The Lake Lothing (Lowestoft) Third Crossing Order 201[*]

Document SCC/LLTC/EX/81: Applicant's Responses to Interested Parties' Representations Submitted at Deadline 4

PINS Reference Number: TR010023

Date: 22 February 2019

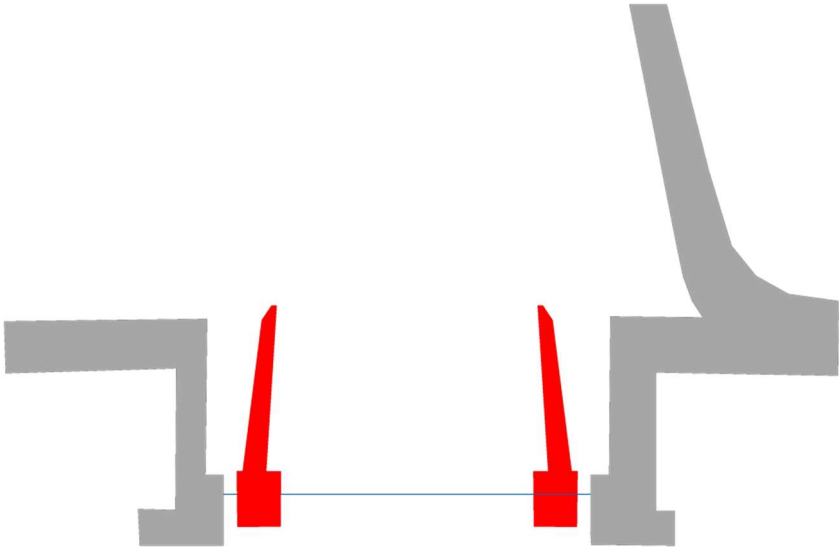
Reference	Extract / Summary	Applicant's response
	<p>at the following times, which may be amended having regard to concurrent demand at the A47 Bascule Bridge."</p> <p>As currently drafted, the clause is deficient. This insertion does not clearly state who an amendment can be made by, and in what circumstances.</p>	
Comments on the draft Scheme of Operation	<p>Scheme of Operation: Comments on Section 8 (Vessel Height)</p> <p>In the absence of a comprehensive Navigation Risk Assessment having been undertaken (and formally approved by the Statutory Harbour Authority), ABP cannot agree to any of the requirements set out in this clause for a number of reasons, including the following:</p> <ul style="list-style-type: none"> • ABP has real concerns, based on decades of experience, that vessels Masters often do not precisely know the air draft of their vessel. • Further, vessels Masters are often unaware of additional pieces of equipment (such as radio masts, aerials, etc) that may increase the air draft of their vessel. • Recreational vessels are often under the control of persons without expansive, or even any, prior experience of the vessel. • It may be that a real-time clearance display is not sufficient to act as a measure designed to mitigate the risk of a vessel strike on a bridge. <p>Accordingly, this section requires further consideration by ABP, as Statutory Harbour Authority, following</p>	<p>Whilst ABP's concerns are understood, the DCO already provides for:</p> <p>a) the recommendations of the final NRA must be carried out (Requirement 11(2)(4)) which would include issues relating to managing air draft risk); and</p> <p>b) the provision of additional navigation markings if determined to be required by ABP pursuant to their protective provisions.</p> <p>Chapter 7 of the Ports Impact Paper (Document Reference SCC/LLTC/EX/59, PINS Reference REP4-015) indicates that the pNRA was taken forward on the basis of the design of the Scheme as it had progressed to the time of the application.</p> <p>The DCO (Document Reference SCC/LLTC/EX/78) has been amended at Deadline 5 to explicitly provide for ABP to approve the final NRA for the Scheme - requirement 11(2)(4), and as noted above, the Applicant must carry out the recommendation measures set out in that final NRA.</p> <p>The requirements for a safety clearance under the bridge during vessel passages with the bridge in the lowered position is well understood by the Applicant. All assessments of anticipated numbers of openings have been based on the inclusion of such a</p>

Reference	Extract / Summary	Applicant's response
	<p>completion and approval of the comprehensive Navigation Risk Assessment, to determine what types of restrictions may need to be imposed.</p> <p>As a practical issue, the ExA should note that the LLTC does not have a clearance of 12 m at HAT in terms of the passage of vessels. Subject to the completion of the formal navigation risk assessment, ABP anticipates that the actual height for safe passage will be 11 m at HAT (incorporating the vessel air draft clearance value) – this vertical clearance will itself be reduced through predicted sea-level rise over the life of the LLTC bridge. That this fact has not been recognised simply goes to underline the Applicant's lack of understanding of port operational issues and matters of safe navigation.</p>	<p>requirement. The effects of sea-level rise have been considered within the ES.</p> <p>ABP's response makes no mention of the very infrequent nature of water levels reaching HAT and that for significant proportions of the time the air draft available will be greater than 12m.</p> <p>Furthermore, HAT is a measure of predictions based on average atmospheric conditions, the water level does sometimes go above this level.</p> <p>The below graph shows the variation of available clearance (including a 1m safety margin) over a typical week (during 2017) derived from tide gauge data.</p>  <p><i>Figure 2-1 Variation of available clearance (including a 1m safety margin) over a typical week (during 2017)</i></p>

Figure 1: Assumed Location of Wig Wags

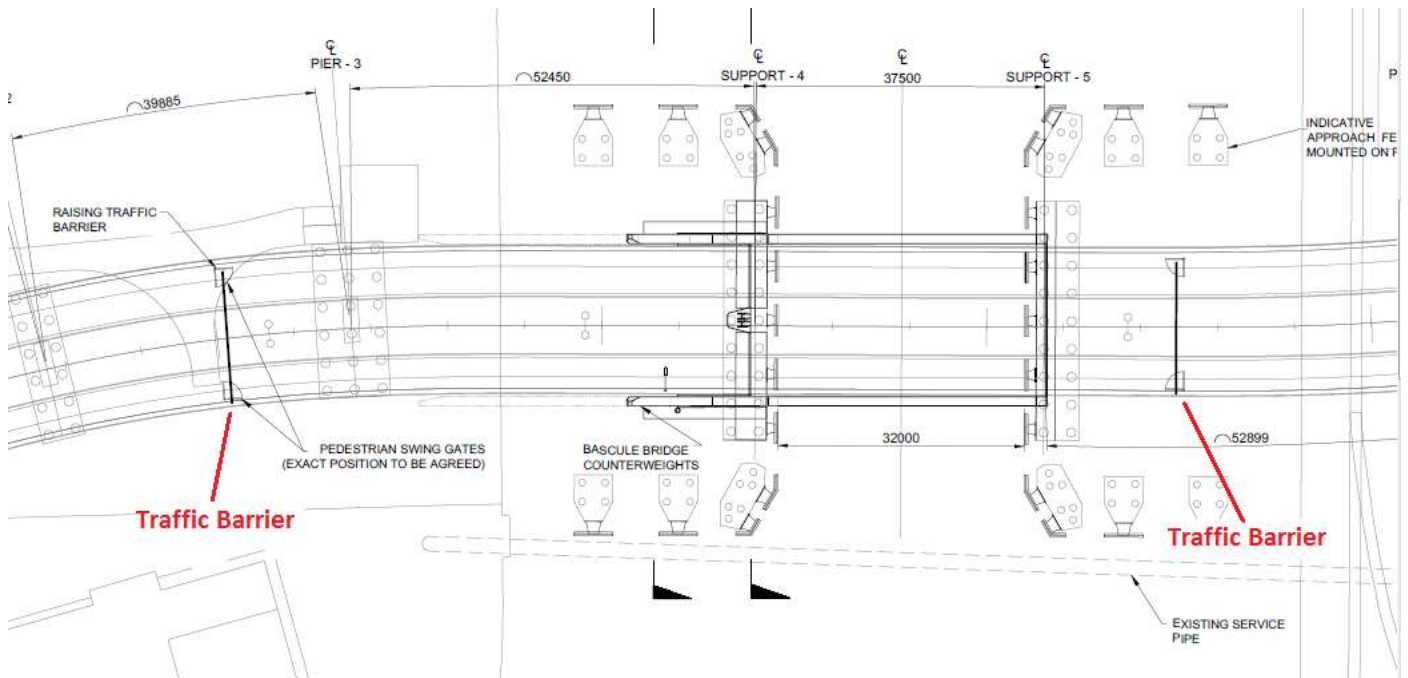
The sound source associated with the wig wags are assumed to be located adjacent to the traffic barriers as identified in Figure 5.3 of the ES (extract reproduced with annotations below).

Figure 1 Journey Time Variability for Do Minimum and Scenarios 7 and 9

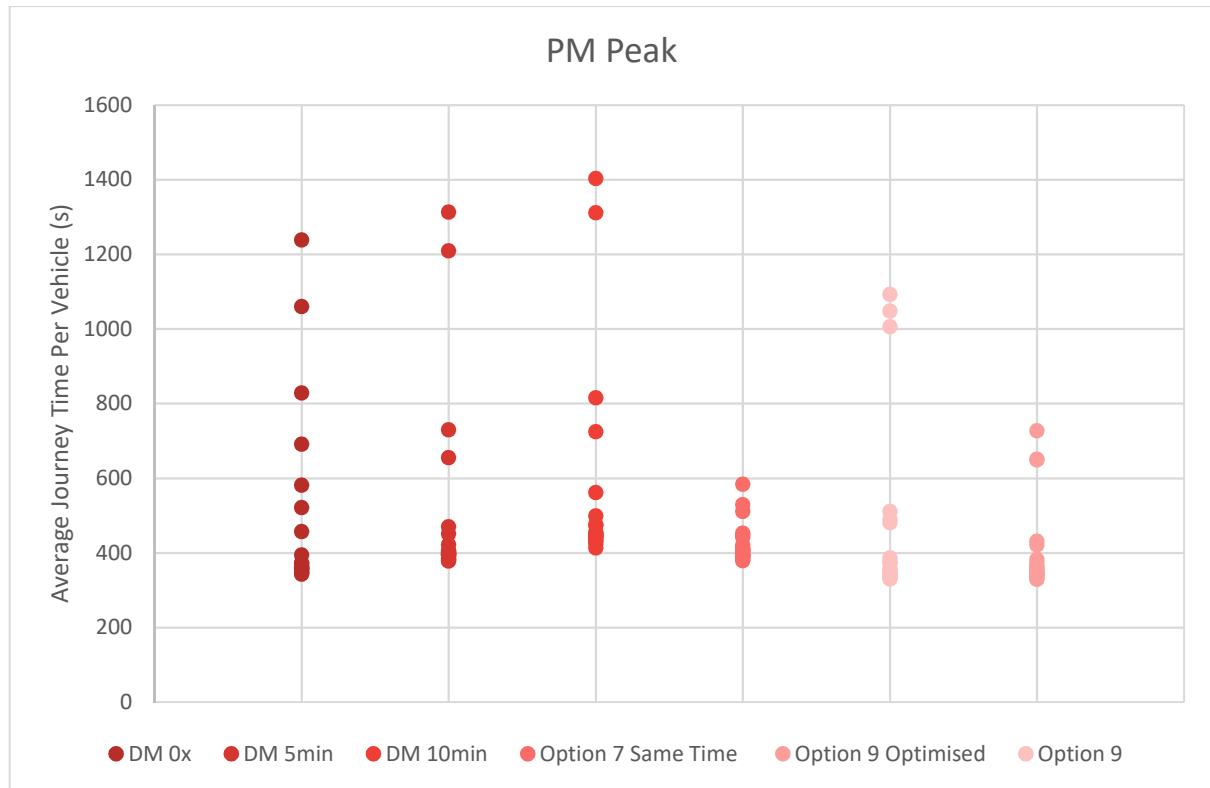
ABP 3. *That could have a fundamental and substantive impact on the overall assessment of scheme benefit. In that regard, ABP has serious concerns that the modelling in any event is counter intuitive. By way of example, Table 7.38 shows higher average travel time savings (111s vs 37s in the PM Peak) for SC 7 (when both bridges are closed for 10 minutes) than Sc 9 when the scheme bridge is assumed not to lift.*

An analysis of the PM peak journey times for each of the 20 runs of the Do Minimum and Do Something scenarios is presented in Figure 1.

Figure 1 demonstrates that in the Do Minimum for both a 5 and 10 minute lift of the Bascule Bridge, there is a significant variation in journey times and reflects the congestion associated with the bridge lifting.

The Journey time variability is significantly reduced for both Scenarios 7 and 9, and the benefit of optimising the A12 Tom Crisp Way/Blackheath Road junction is also clear.
